BORDER FORTS
NUMBERED 602, 604,
628, AND 634
SULAYMANIYAH, IRAQ

SIGIR PA-05-021

SUBJECT: Report on Project Assessments of Border Forts Numbered 602, 604, 628, and 634 in Sulaymaniyah, Iraq (Report Numbers SIGIR PA-05-021, PA-05-022, PA-5-023, and PA-05-024)

Border Forts Numbered 602, 604, 628, and 634 Sulaymaniyah, Iraq

Site Photo 21 & 22. Generator Factory Nameplates (Safrah #634 Border Post)

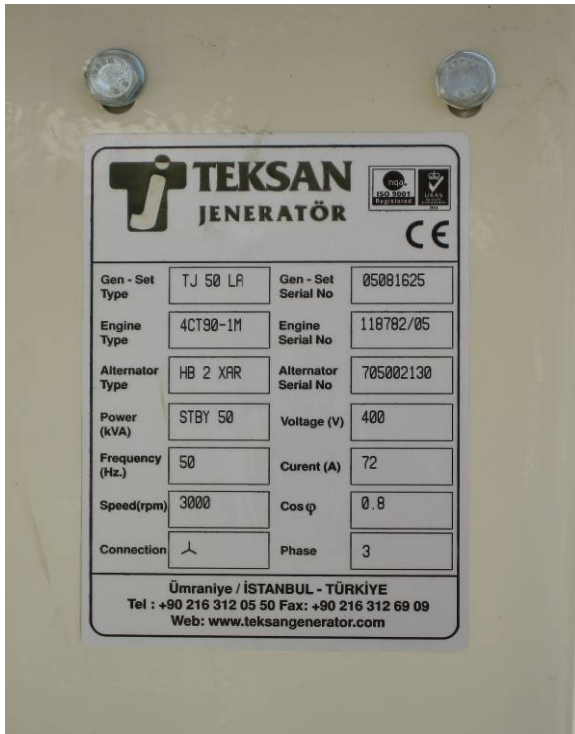
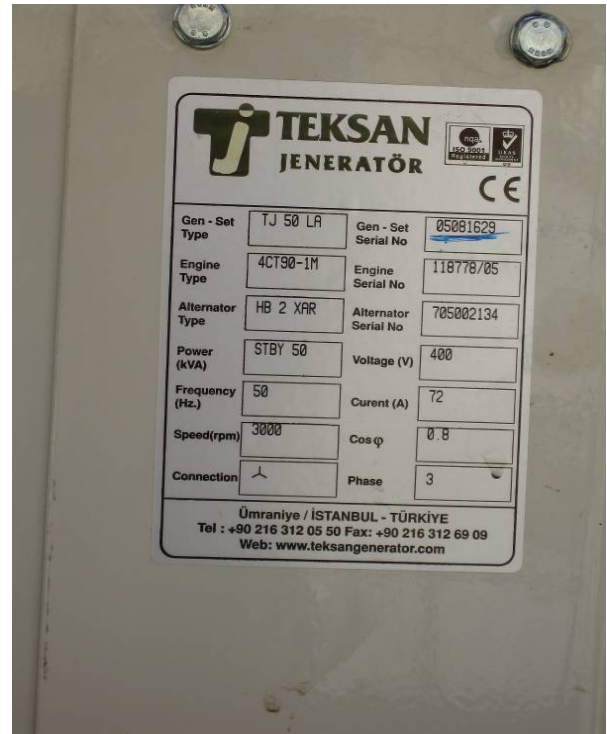
The contract and design required the installation of a generator and standby generator rated at 60 percent of the rated power of the main service panel and fuel storage tanks. The generators were to be mounted on a concrete reinforced pad with a metal framed wire mesh enclosure with a corrugated roofing system. During the site visit, we verified that two generator units were installed on a concrete pad with metal enclosure. In addition, two fuel tanks were installed on concrete pads. The fuel tank measured 18.25 ft (5.6 M) long and 5.1 ft (1.6 M) in diameter. The generators were operating under load at the time of the site visit.

Site Photo 20 shows the two generator units, metal enclosures, and two fuel storage tanks. Site Photos 21 and 22 show the factory nameplates of the generator units.

**Site Photo 30. Front Exterior View of Border Post
(Marwa #628 Border Post)**

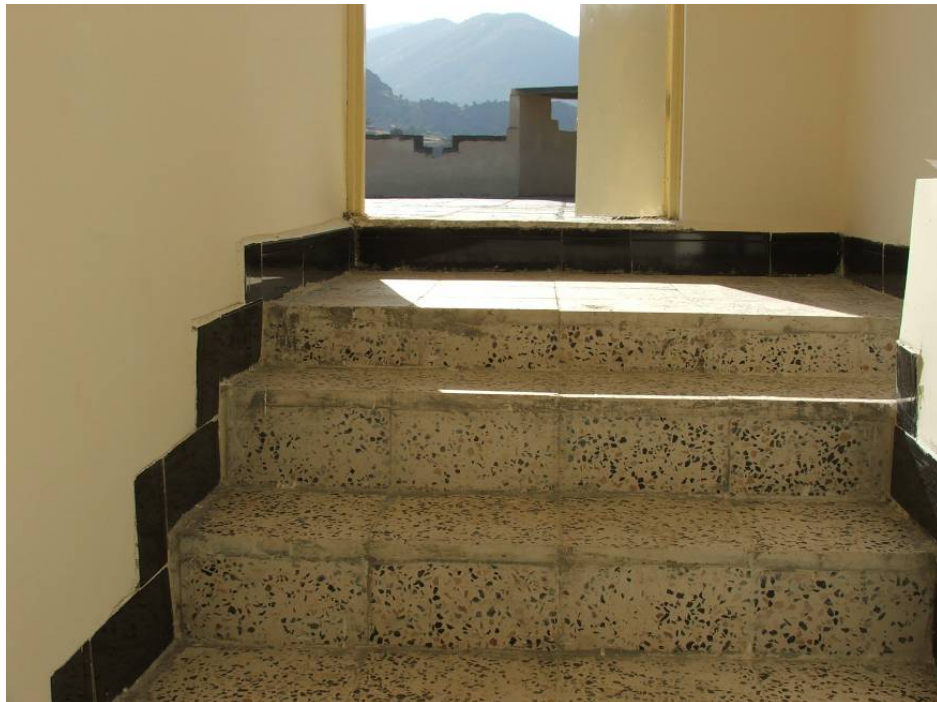
During the site visit, we verified that the facility was completed, that it was constructed with block exterior, and that the electrical systems were installed. Electrical power was not on during the site visit. Site Photo 30 shows the exterior front of the border fort facility and Site Photo 31 shows the roof, parapets, and flagpole.
